APIWELL#	Well Name	Well #	Operator Name	Type	Stat	County	Surf. Owner	UL	Sec	Twp	N/S	Rng	W/E
30-045-11147-00-00	UTE INDIANS A	004	XTO ENERGY, INC	G	A	San Juan	U	I	35	32	N	14	W

PLUG AND ABANDONMENT PROCEDURE

Ute Indian A #04

Conditions of Approval - Notice of Intent to Abandon:

Proposed P&A

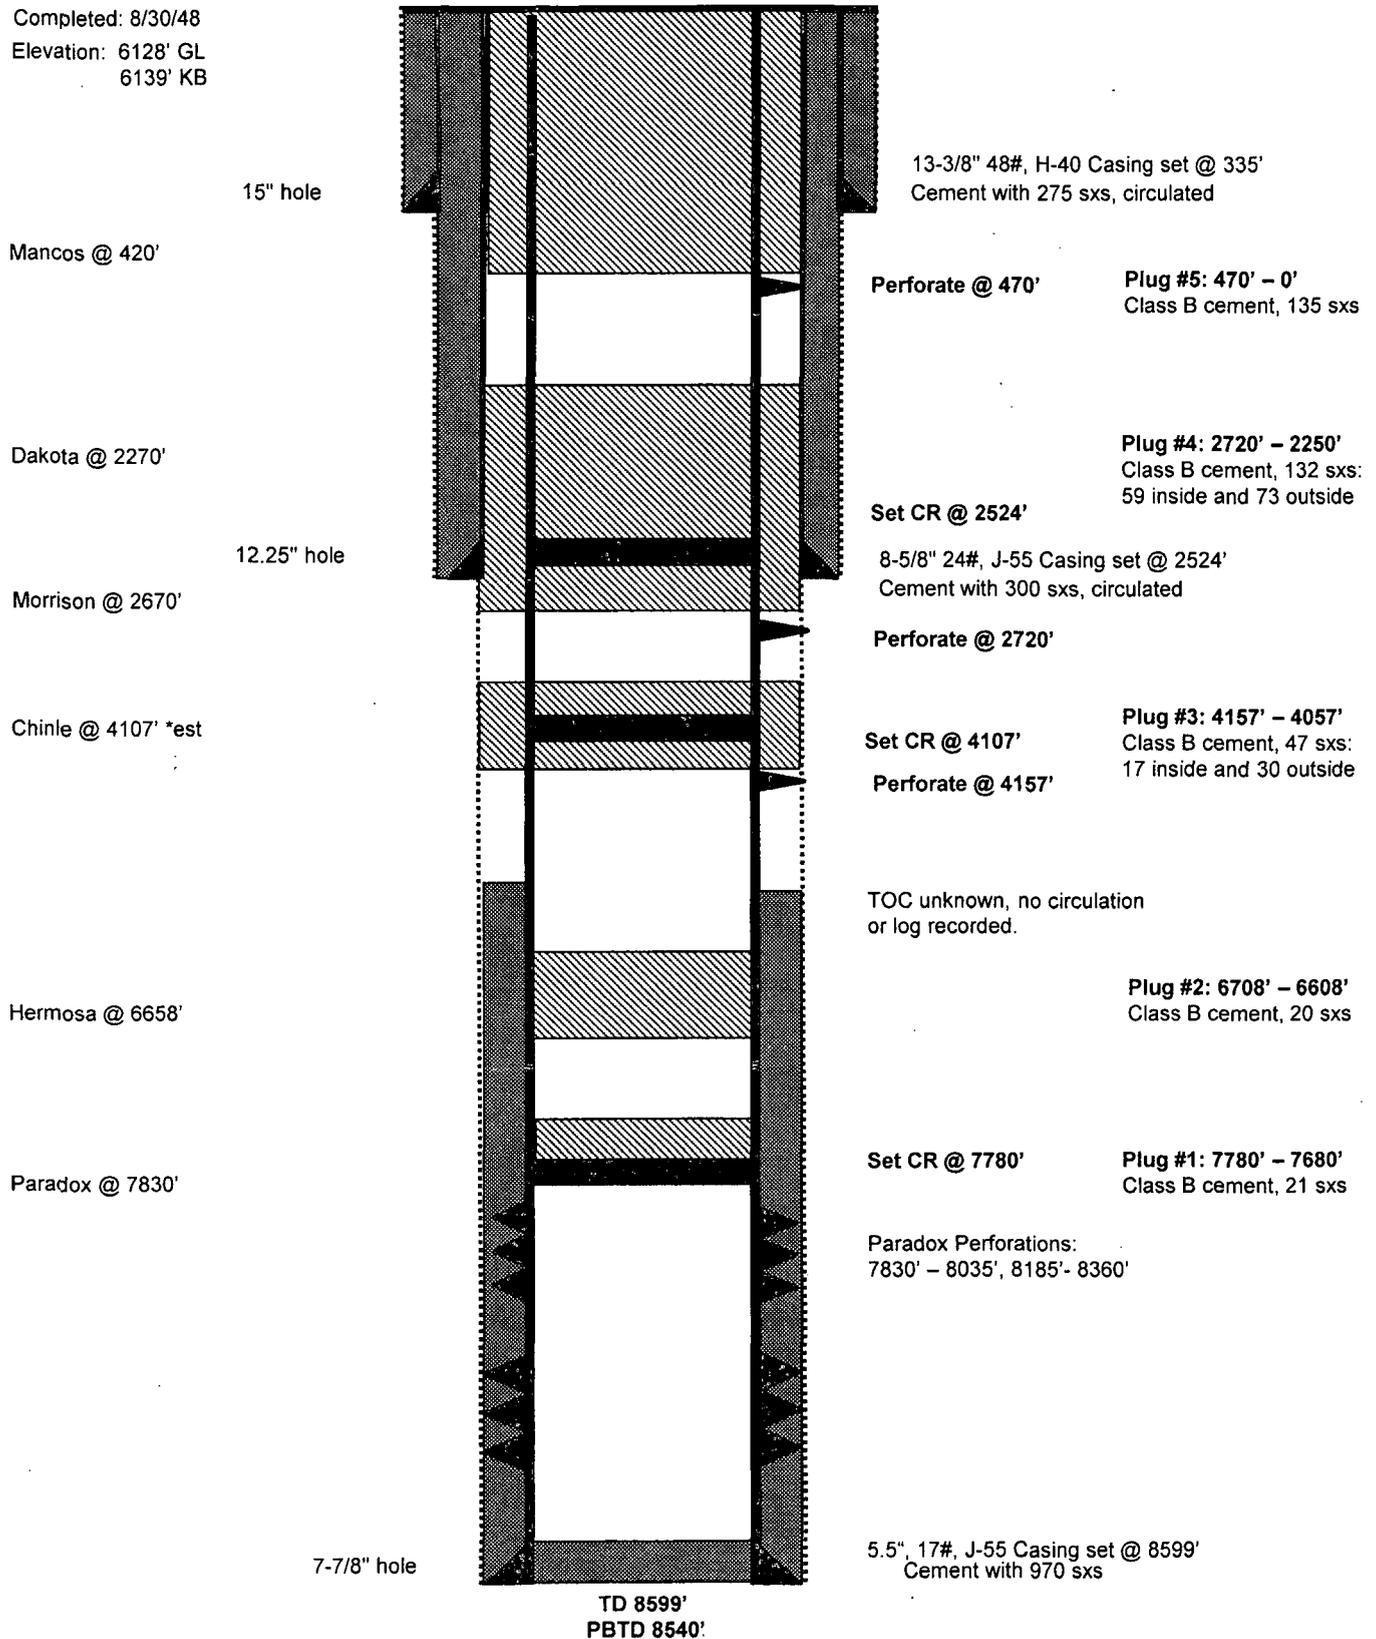
Extend plug 1 from 7780 to 7600

Extend Chinle plug to 3922

Add Entrada plug 3440-3540

Extend Morrison/ Dakota plug to 2155 to cover Graneros

Add Gallup plug 1395-1495
